Compute Summit

Open Rack Workshop

Open Rack Standard Update

V1.1

Standard: Reserve PDU Volume

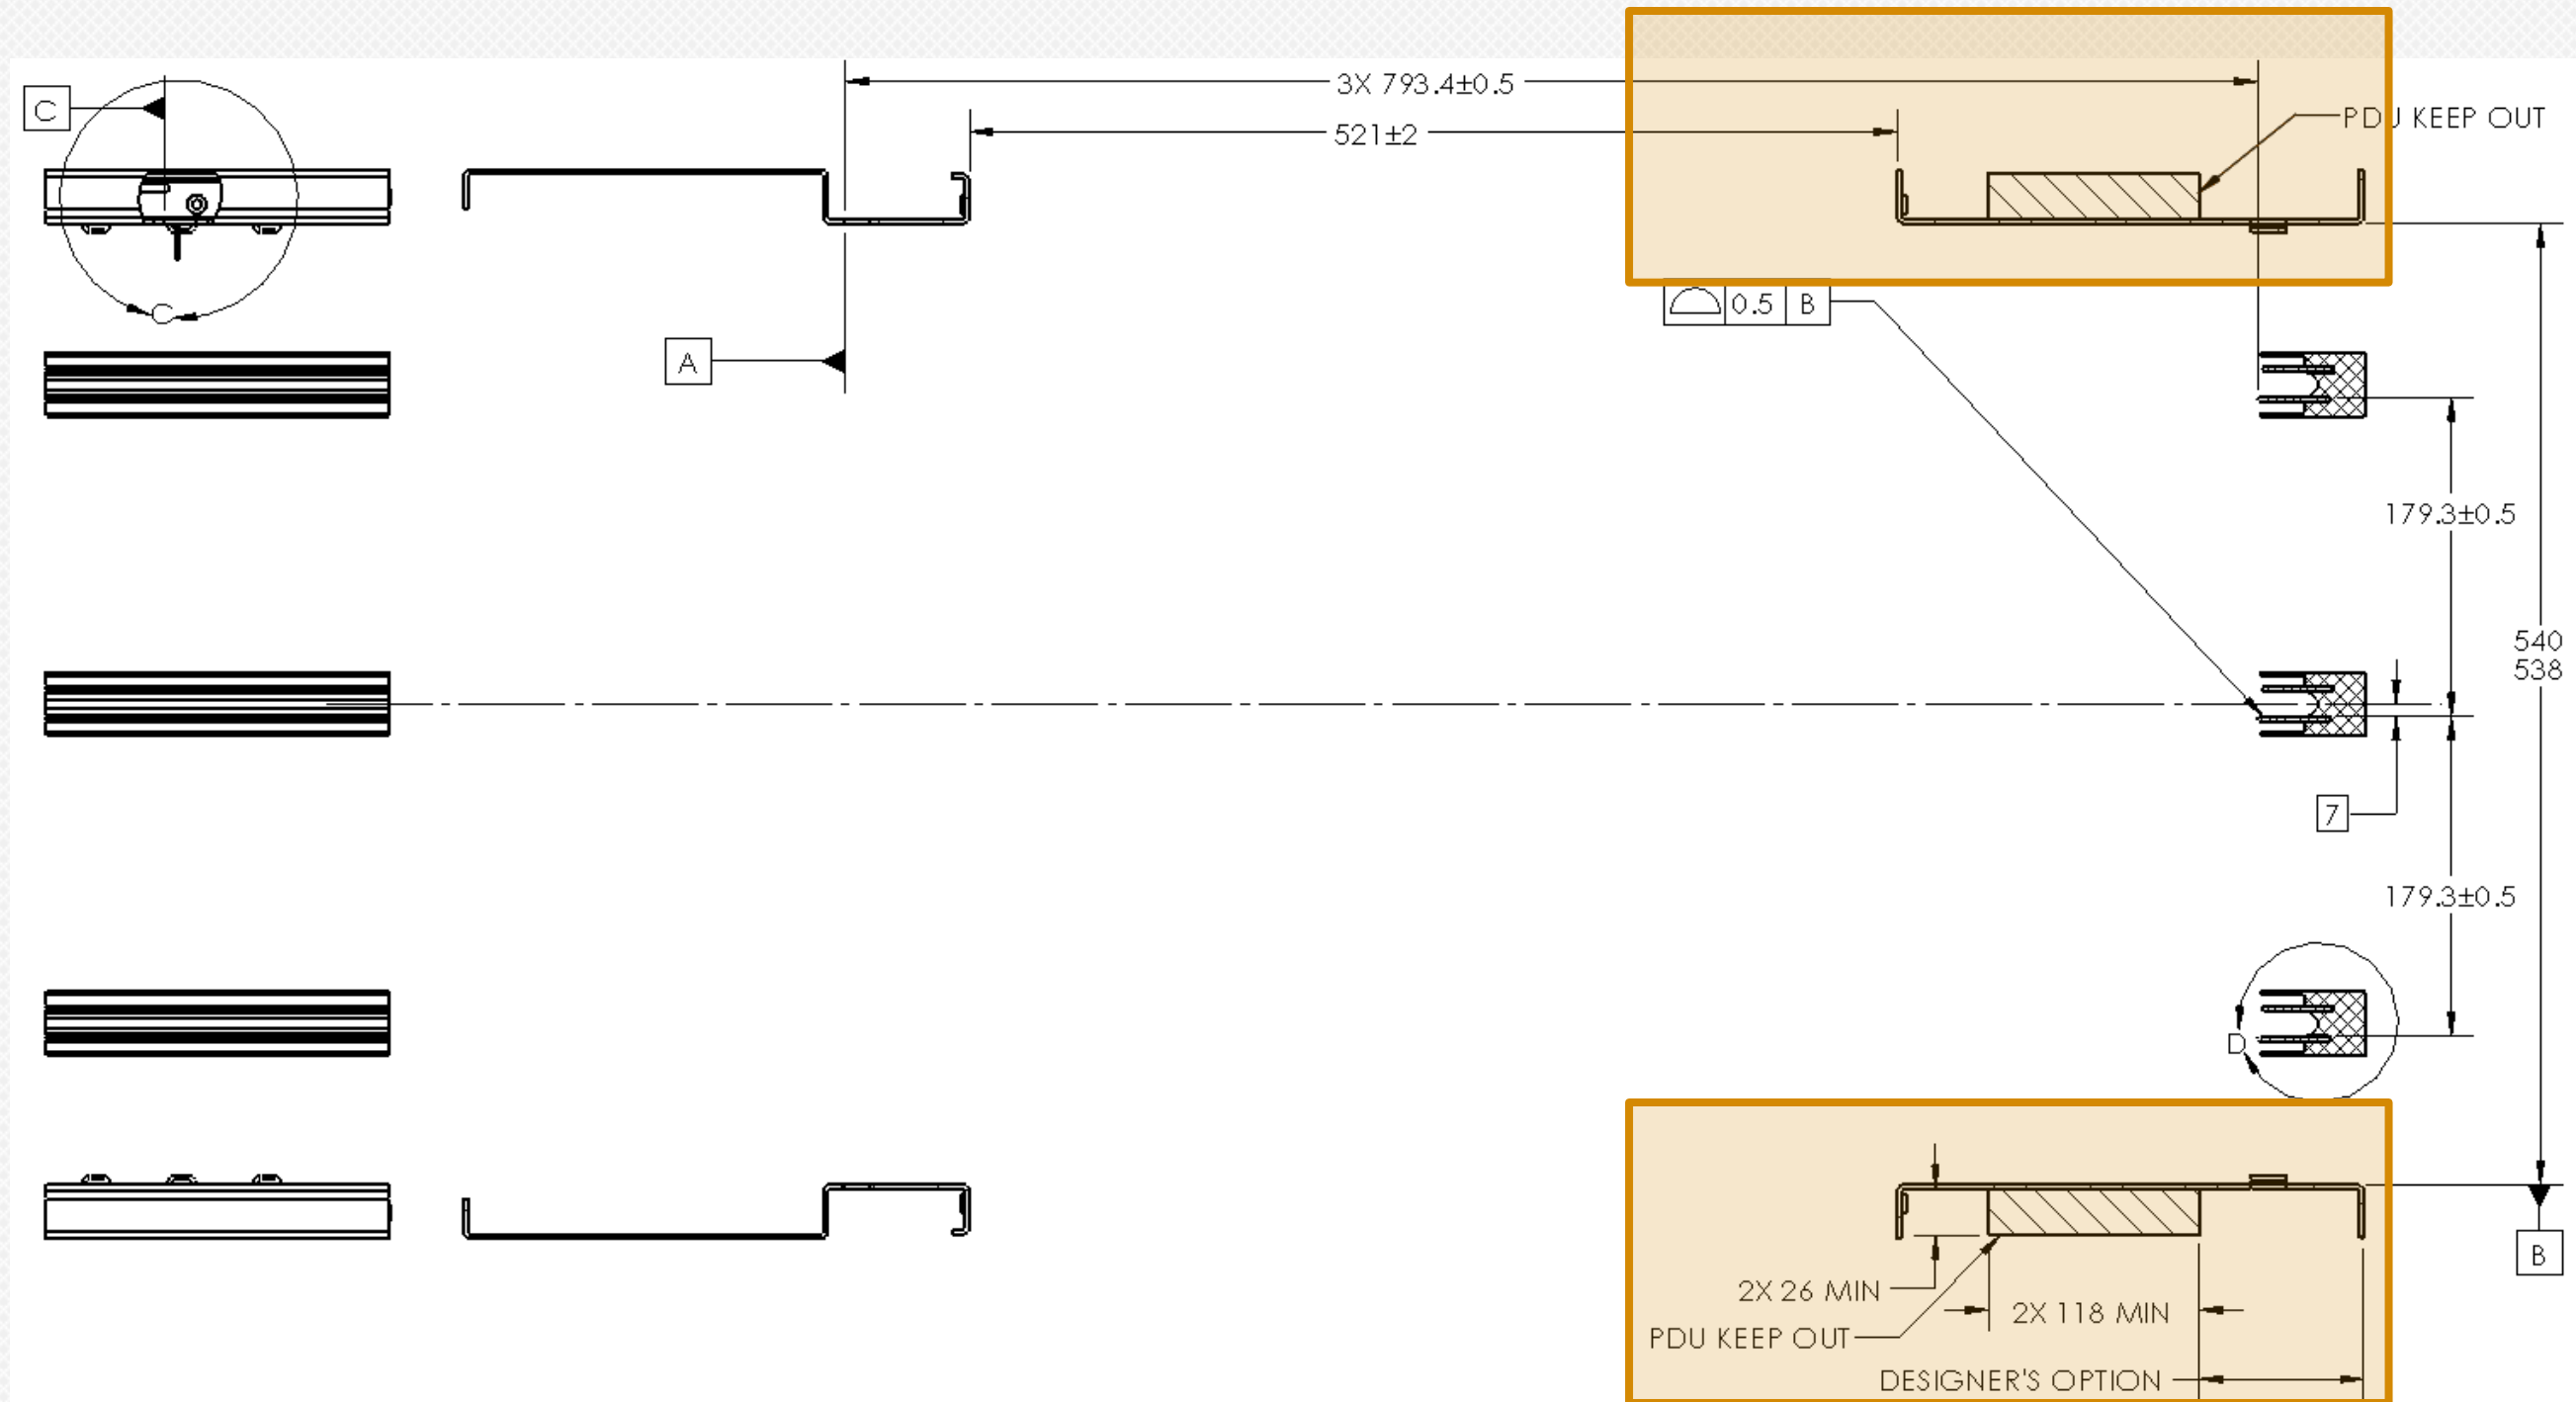
SECTION B-B
IT GEAR SUPPORT BRACKETS REMOVED

Standard: IT Support Brackets

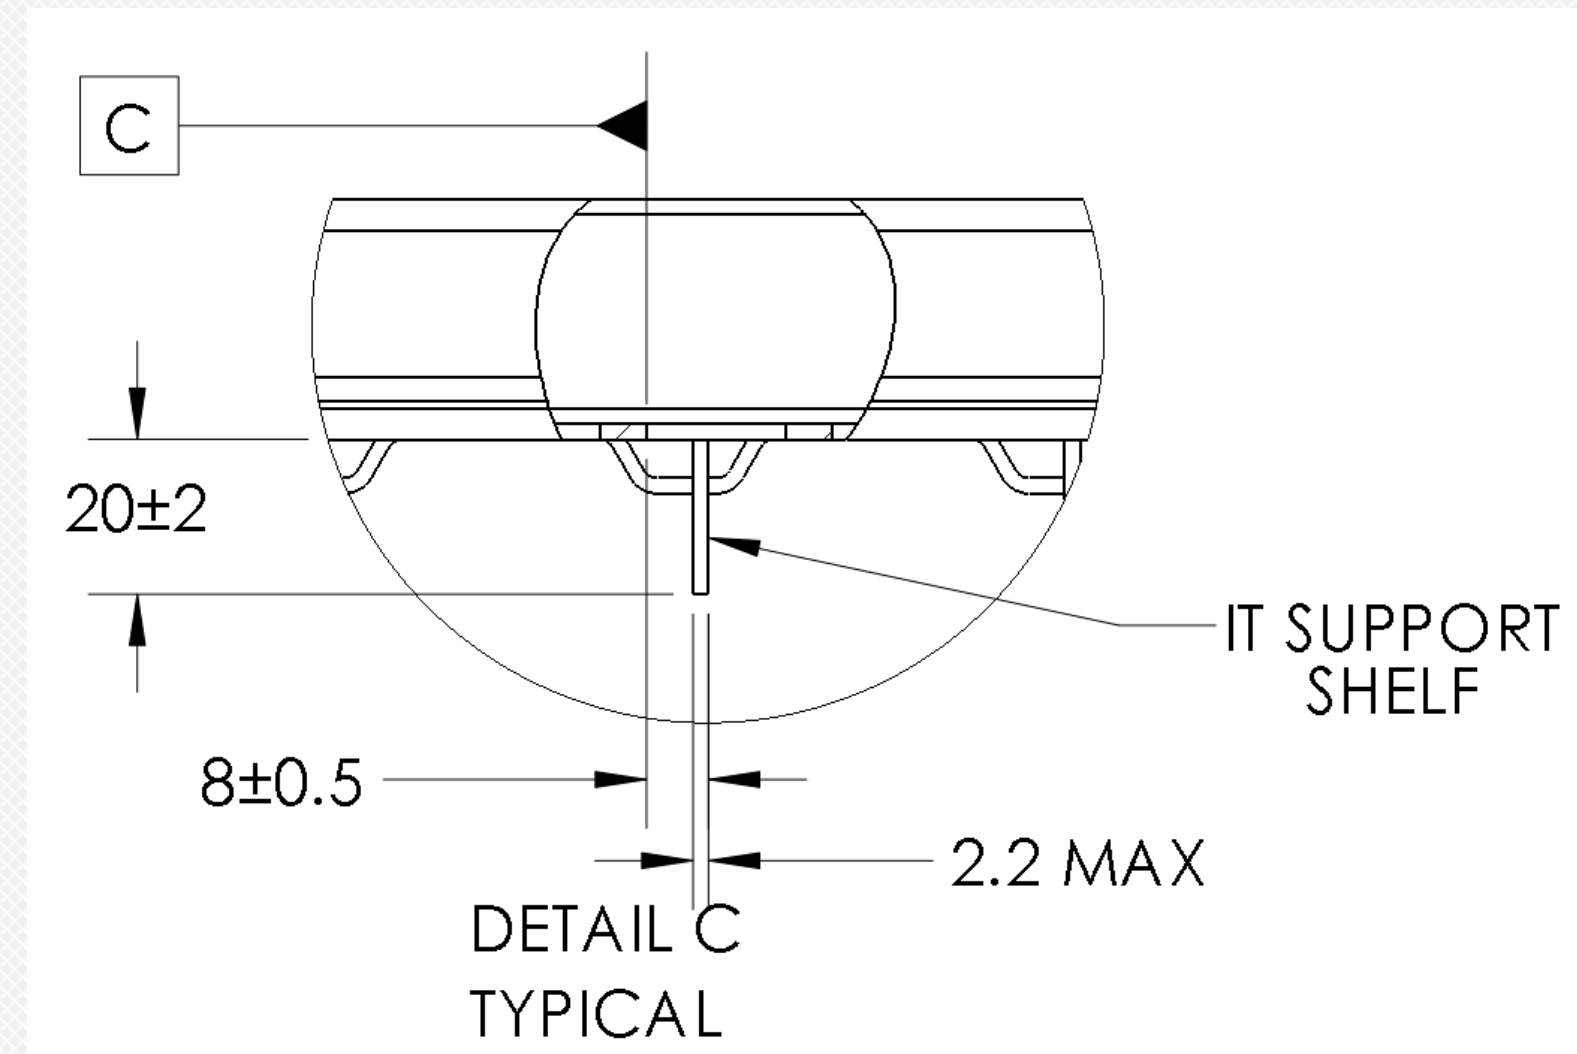
- Conform to the shape shown in Detail C (Figure 7). If the IT Support Bracket is continuous along the entire width of the rack instead of two Support Brackets, than the 20mm bracket length in Detail C may be ignored.
- IT load changed to 700N per set

Add connection for Power Shelf to Rack Busbar

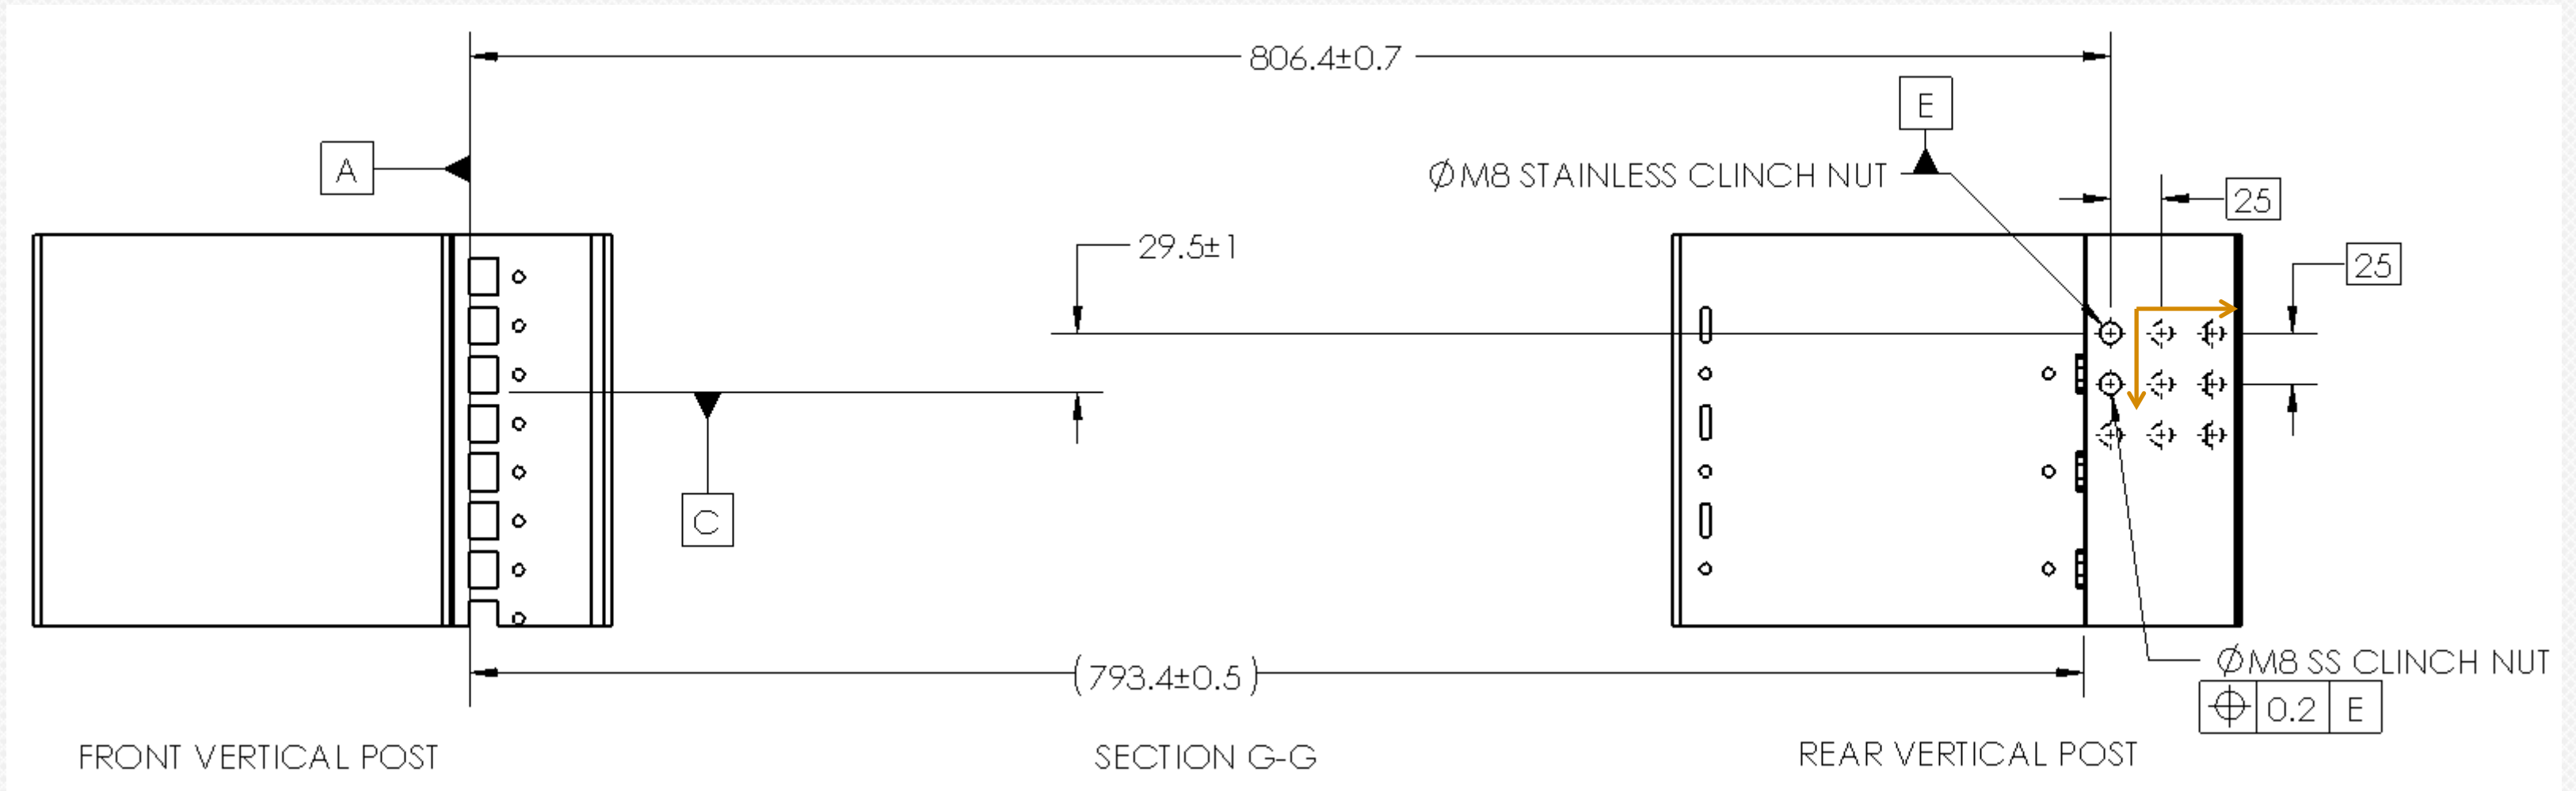
Start with Hole at Datum E and add holes to the busbar in a 25x25 array
